Application for a works approval amendment

Works approval number	W6330/2019/1
Works approval holder	Koojan Downs Pty Ltd
ACN	628 244 628
DWER file number	DER2019/000581
Premises	'Koojan Downs' Cattle Feedlot 1131 Boundary Rd YATHROO WA 6507
Date of report	23 November 2021
Status of report	Updated final

Amendment description

This amendment relates to infrastructure changes regarding the proposed Koojan Downs cattle feedlot, which is subject to works approval W6330/2019/1.

▲ **Figure 1: Original proposed sedimentation basins 2 & 3 for CDA 1 (orange)**

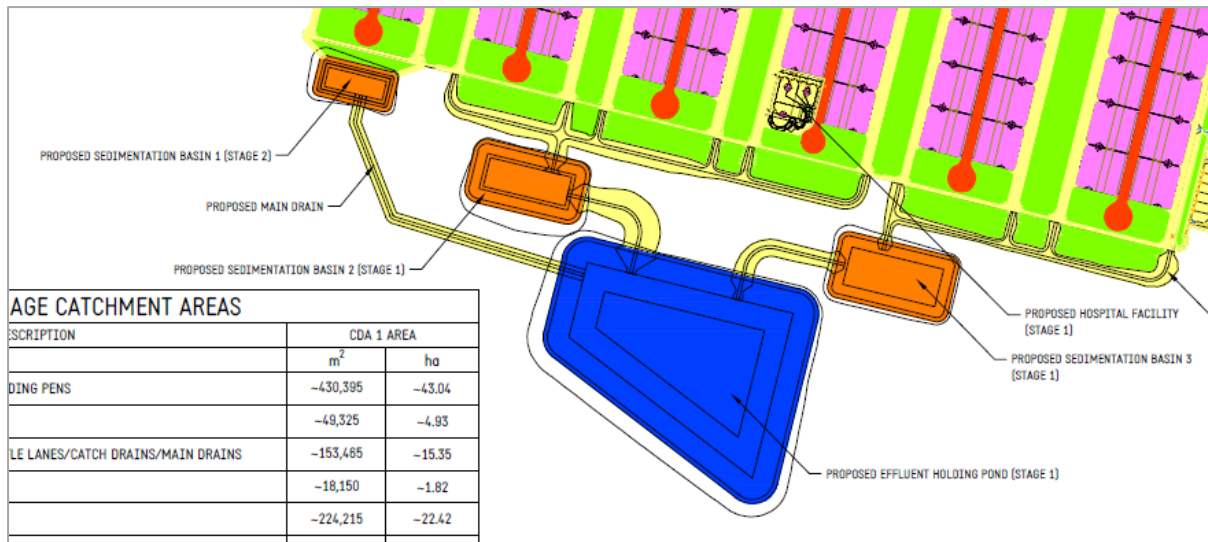
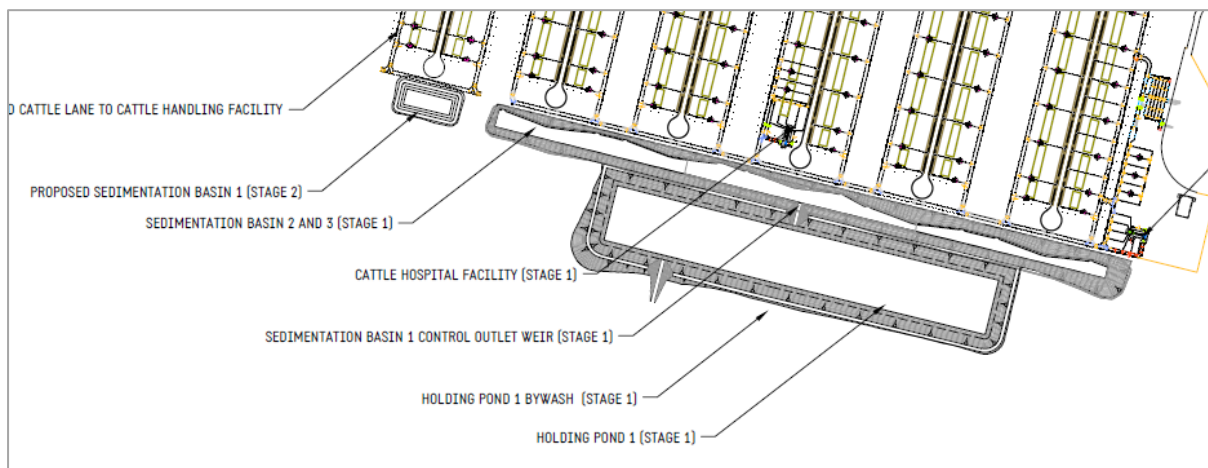
The initial works approval application (RDC Engineers 2019) proposes the construction of three dedicated sedimentation basins to service controlled drainage area 1 (CDA 1), with minimum proposed storage volumes of 2,000 m³, 3,500 m³ and 5,000 m³, respectively.

The existing works approval requires sedimentation basins to be designed with system volumes of between 1,775 m³ and 5,000 m³, with the three proposed basins for CDA 1 having volumes of 5,000 m³, 3,500 m³ (Stage 1) and 2,000 m³ (Stage 2) (Figure 1).

To obtain additional fill material for the earthworks design (Figure 2), the works approval holder proposes to consolidate the two separate sedimentation basins proposed in Stage 1 into one larger basin, with a capacity equal to the combined capacity of the individual basins, i.e., 8,500 m³.

The delegated officer has considered the proposal to consolidate the two smaller

sedimentation basins for CDA 1 into one larger basin, noting the overall volumetric capacity will remain unchanged from the original design.

Analysis indicates the water containment infrastructure sizing calculations appear to be conservative based on the limited information provided with the application, however DWER is unable to verify the reliability of the results without more detailed water balance calculations. The delegated officer also notes there are inconsistencies elements with the information provided, in particular, the reports submitted by RDC Engineers (2021) and Johns Environmental (2019) use inconsistent language and terminology, make references to different controlled drainage areas that have not been clearly defined, and do not provide a year-on-year water balance. For example, it is unclear whether there will be any residual volume remaining in the ponds, and whether this has been accounted for in the water balance calculations.

The delegated officer has therefore determined to authorise the consolidation of the CDA 1 sedimentation basins into one larger basin, however, a more detailed water balance is required to determine whether the proposed containment infrastructure is appropriately sized for ongoing operations (e.g., includes cumulative winter runoff calculations and all proposed management of effluent volumes (e.g., use in composting, effluent irrigation, etc.), or whether additional management measures or controls are required. Should a more detailed water balance indicate that existing conservative predictions underestimate necessary sedimentation basin capacity, the works approval holder will need to rectify this issue, which may include a requirement to provide additional basis storage capacity.

▲ **Figure 4: Proposed separate solid waste stockpile and carcass composting areas**

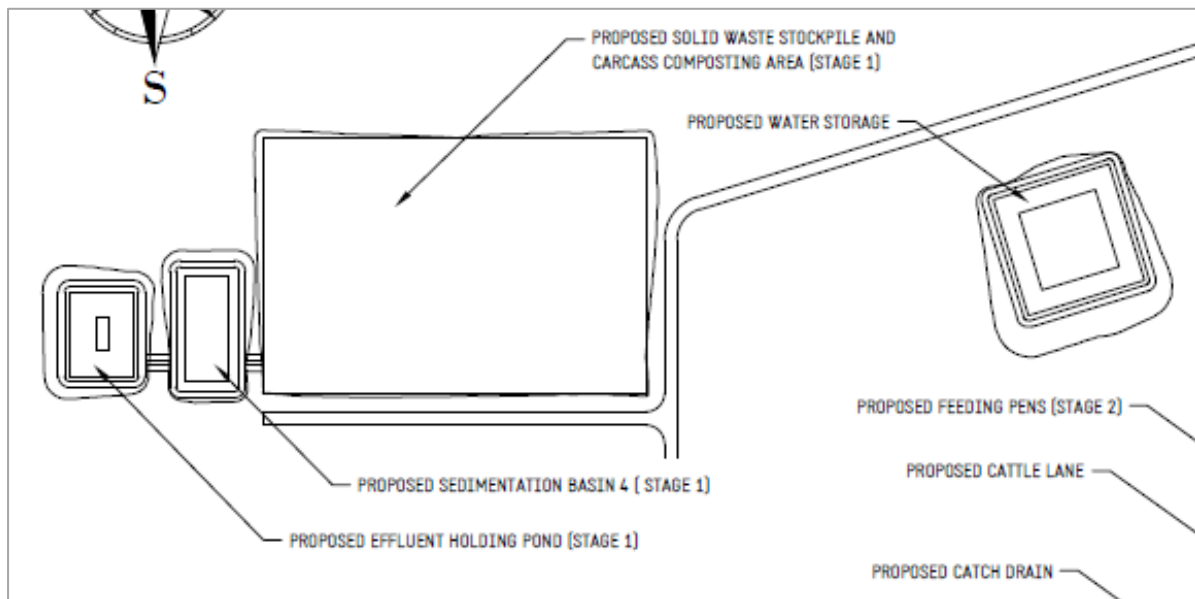
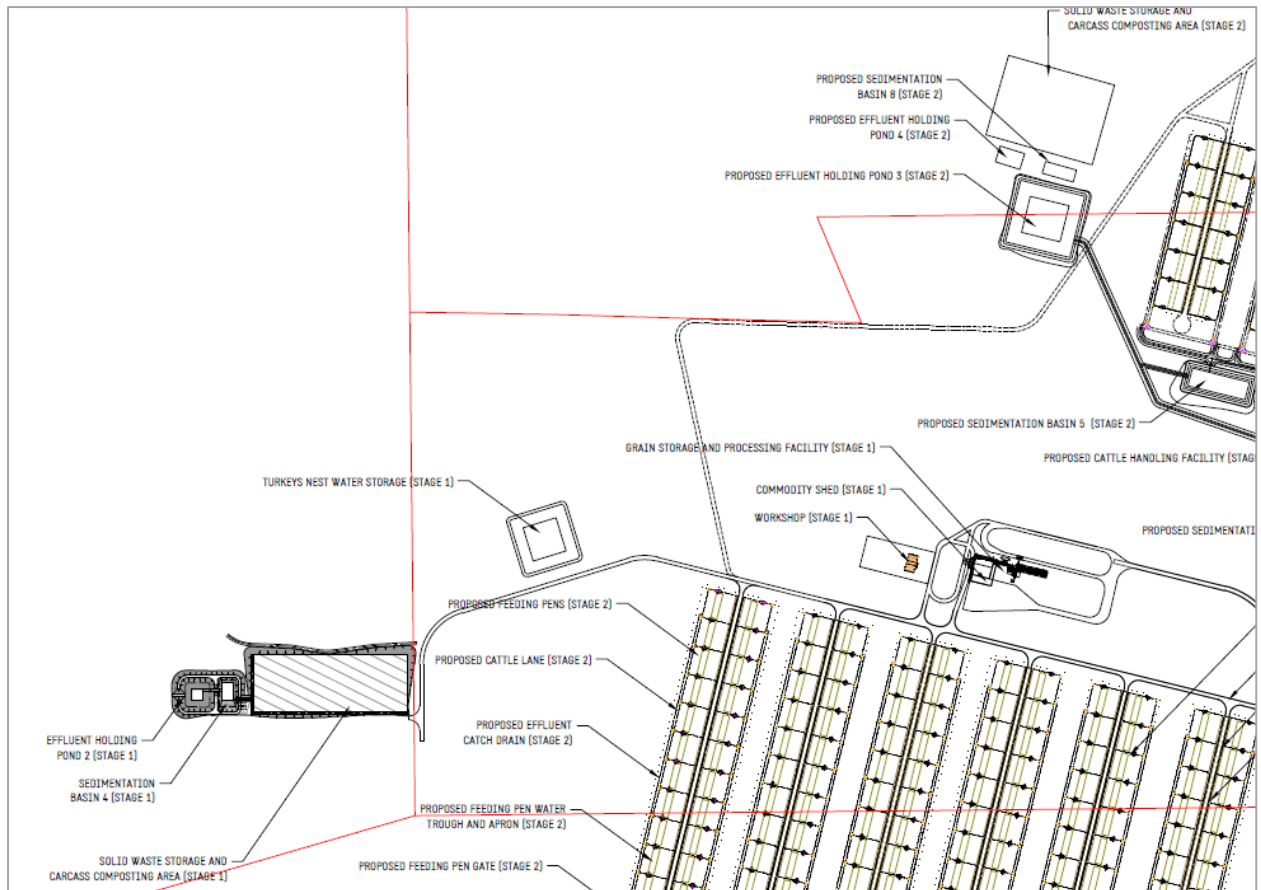
The existing works approval requires construction of a solid waste stockpile and carcass composting area with a minimum surface area of 60,000 m² (Figure 3).

The works approval holder now proposes to construct separate areas for this purpose for each of Stage 1 and Stage 2, to enable staged development and to have dedicated areas for managing the volumes of solid waste and mortalities generated from each stage (Figure 4).

The storage, processing and/or composting of solid wastes from Stage 1, including the composting of mortalities from Stage 1, will be undertaken on a suitably designed and constructed area within CDA 2. Similarly, the storage, processing and/or composting of solid wastes for Stage 2 will be undertaken on a suitably designed and constructed area within CDA 4, in addition to the composting of mortalities.

The works approval holder has assumed windrow dimensions of about 25,000 m² of pad area is required to store and harvest manure for each stage, with an area set aside for composting mortalities adjacent to the manure stockpiles. The pads to be constructed will each comprise a total surface area of about 30,000 m².

Each solid waste stockpile and carcass composting area will constitute its own controlled drainage area, with each to be constructed with a dedicated sedimentation basin and effluent holding pond. The minimum storage capacity of each sedimentation basin is 1,000 m³ and each effluent holding pond 3,000 kL, which the works approval holder considers to be sufficient to retain runoff from a 95th percentile wet year.

The delegated officer has considered the proposal to stage the development of the solid waste stockpile area, by constructing separate stockpile areas for each stage of the project.

It is noted the solid waste stockpile and carcass composting area proposed in the initial works approval application was sized on the estimated volume of solid waste proposed from the full development, with the proposal now to essentially split this area in half and construct separate stockpile areas, each with their own controlled drainage area, sedimentation basin and holding pond.

Whilst the delegated officer does not object in principle to this proposed change, which will be

authorised through this amendment process, a more detailed water balance is required for these proposed changes to demonstrate the containment infrastructure is appropriately sized.
